## Product Change Notice (PCN)

**PCN Number:** PCN-0374226R-01

- CPE 1785

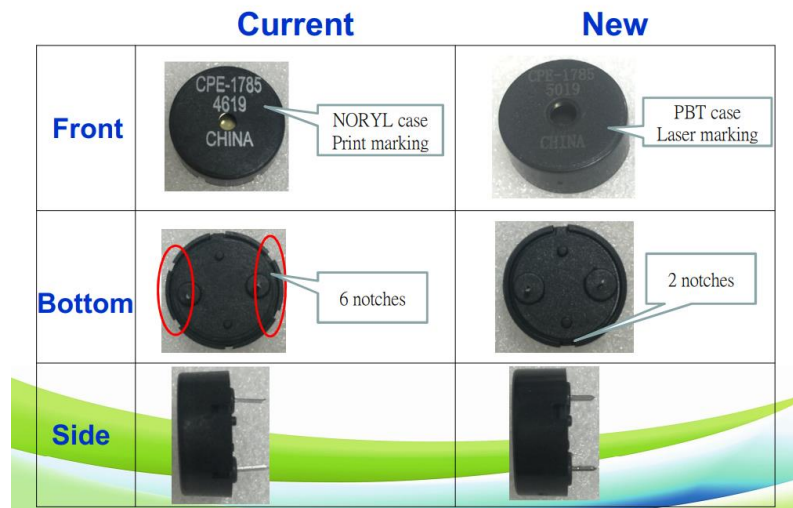
#### ❖ Appearance

- Case markings Change from NORYL case to PBT
- Bottom notches going from 6 to 2

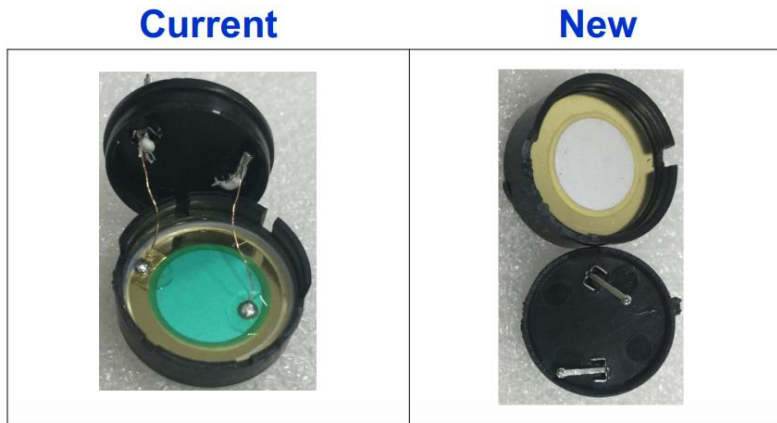
- ❖ **Inside structure**
  - **Change from solder mask on inside to spring contact**

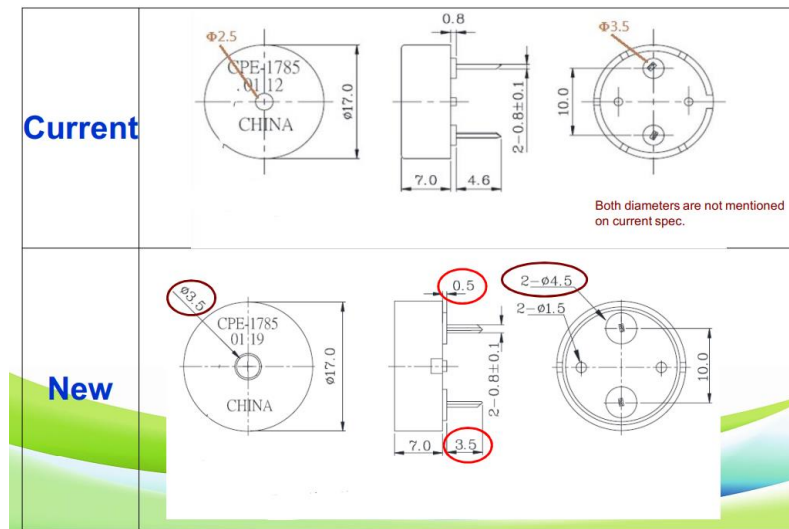
- ❖ **Pin length from 4.6mm to 3.5mm**
